1 LAWSON SQUARE
REDFERN

for
LAWSON SQUARE PTY LTD.

SECTION 96 APPLICATION
ISSUE J
07 DECEMBER 2017

SCHEDULE OF
KEY AMENDMENTS

DRAWING:
LEVEL 17 & 18 PLANS
DRAWING No:
S96 - 1107

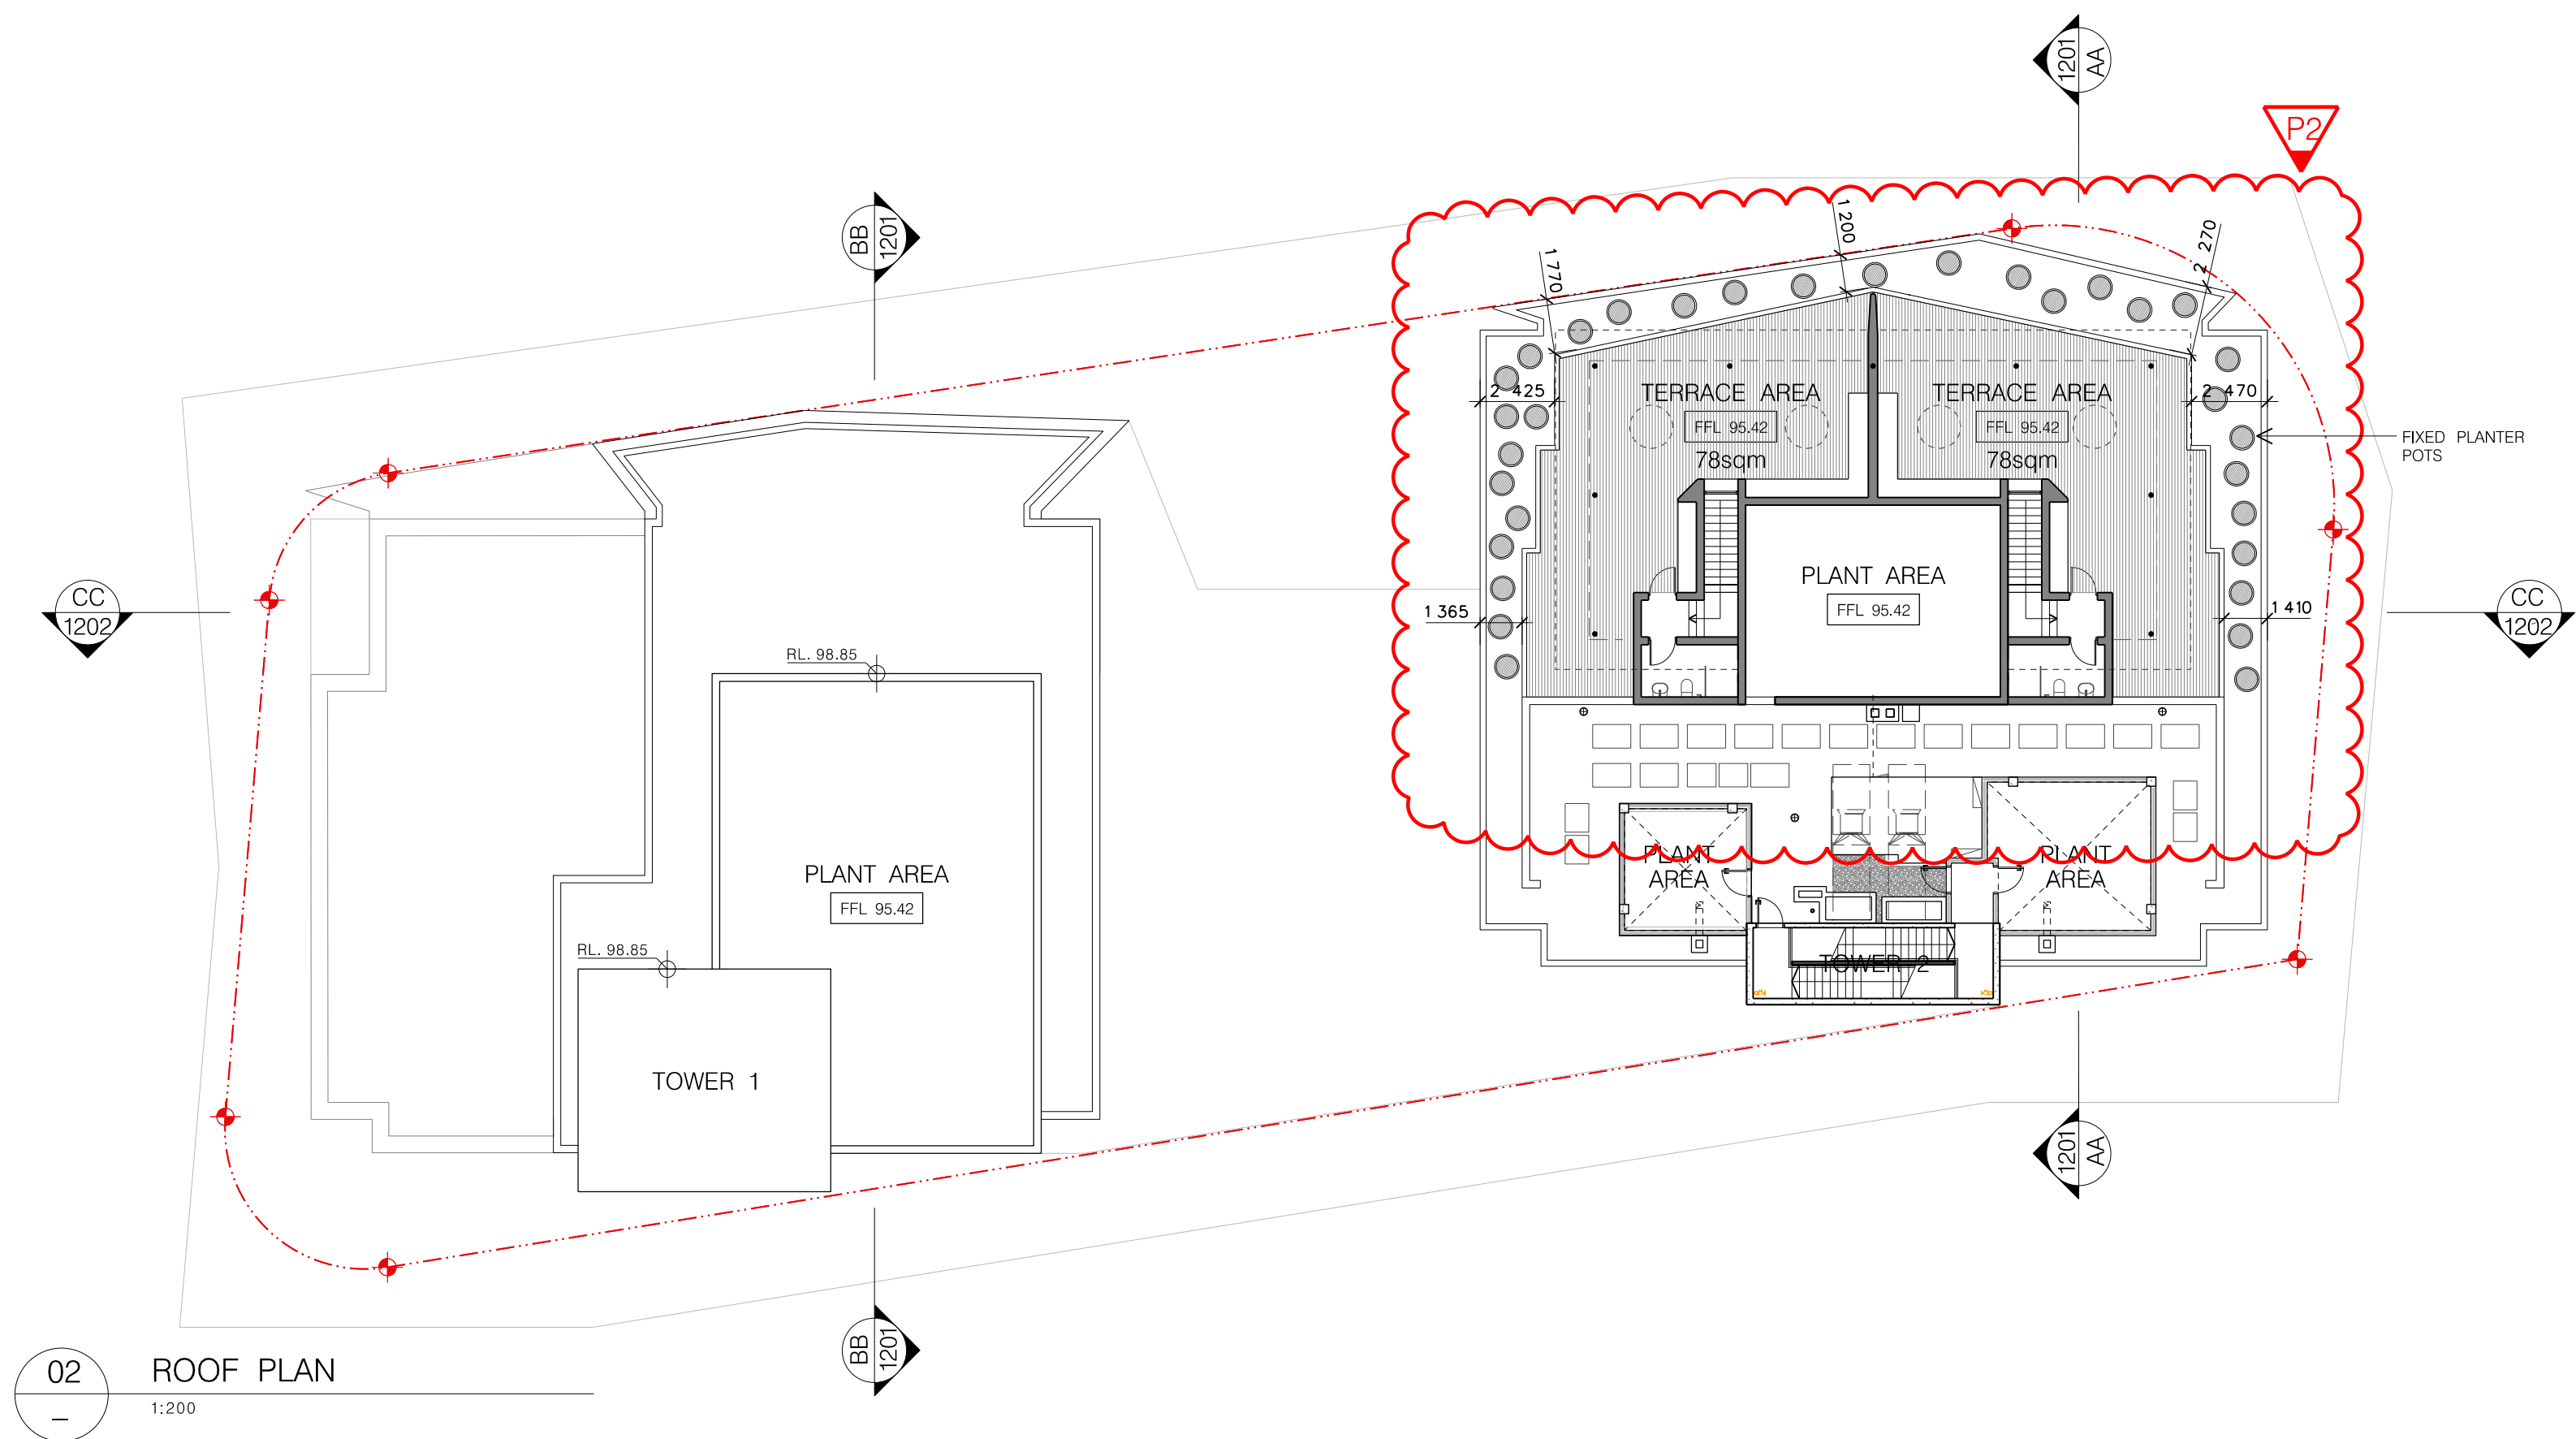
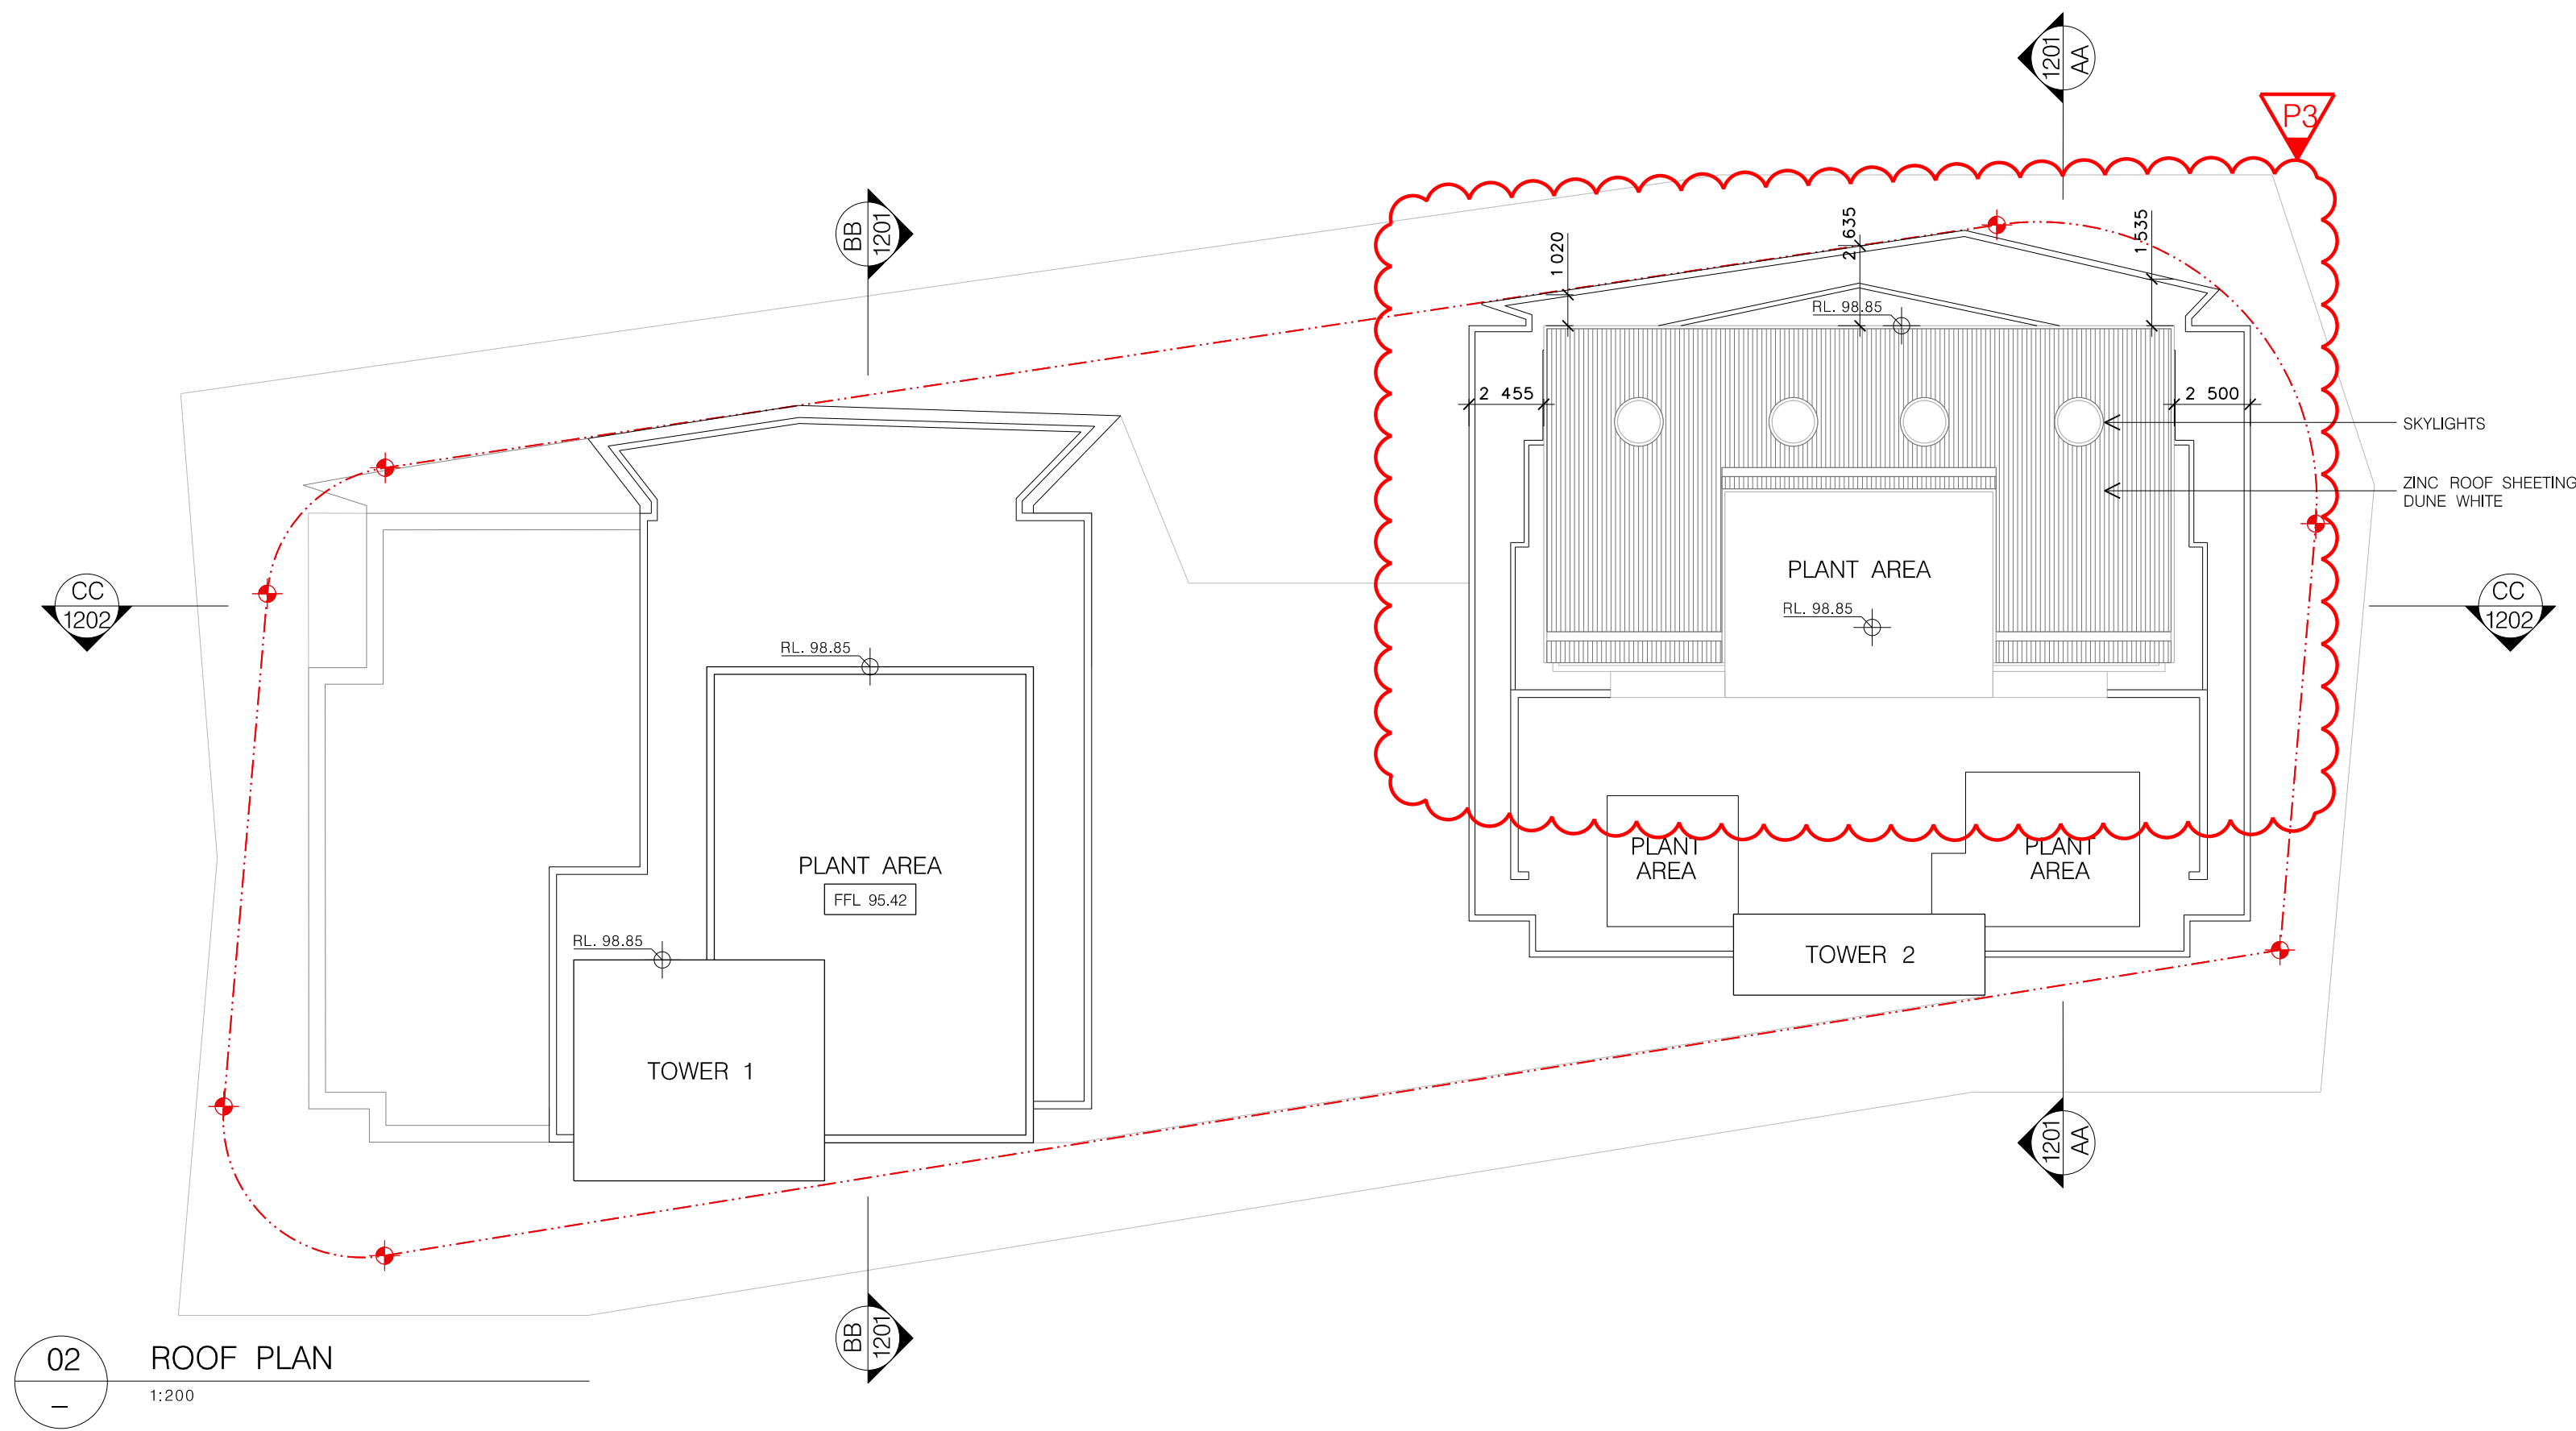
- 1 STAIRS TO ROOF TERRACE ADDED
- 2 PROPOSED TERRACE AREA & AMENITIES ON PLANT LEVEL 18
- 3 NEW ROOF STRUCTURE ADDED OVER PROPOSED TERRACE AREA
- 4 GFA CALCULATIONS AMENDED

DRAWING:
SECTIONS - SHEET 2
SECTION CC
DRAWING No:
S96 - 1202

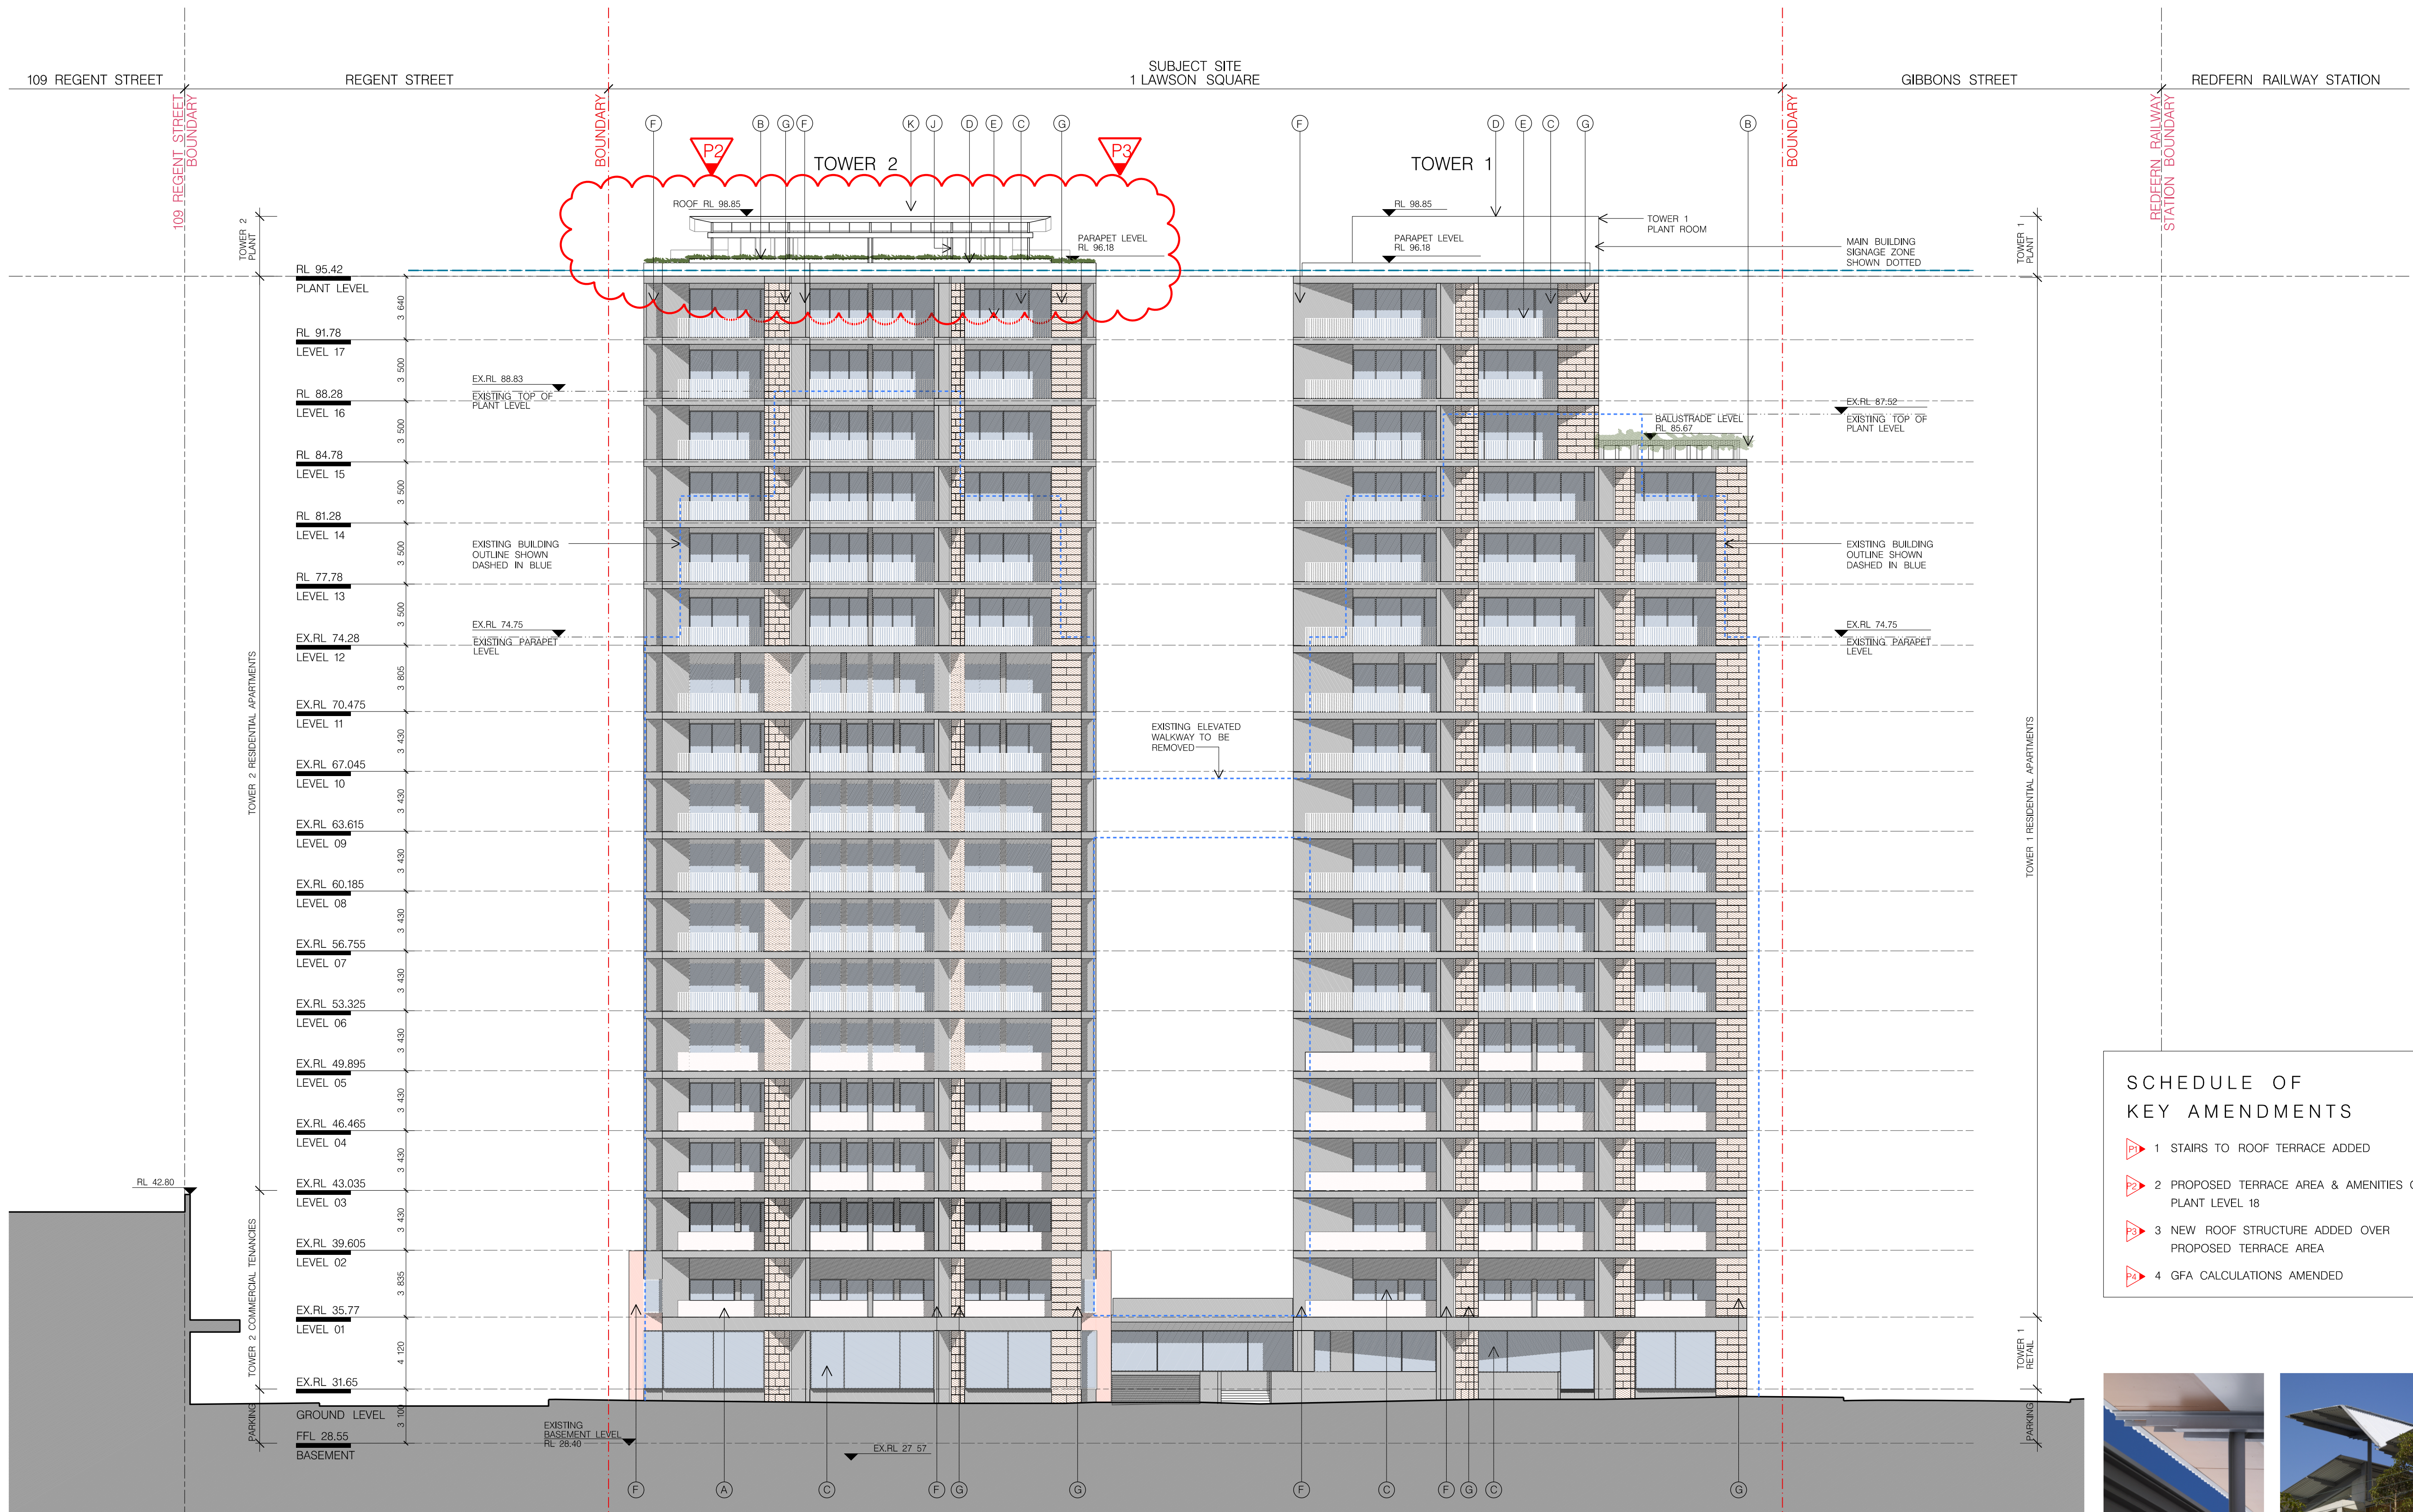
- 1 STAIRS TO ROOF TERRACE ADDED
- 2 PROPOSED TERRACE AREA & AMENITIES ON PLANT LEVEL 18
- 3 NEW ROOF STRUCTURE ADDED OVER PROPOSED TERRACE AREA
- 4 GFA CALCULATIONS AMENDED
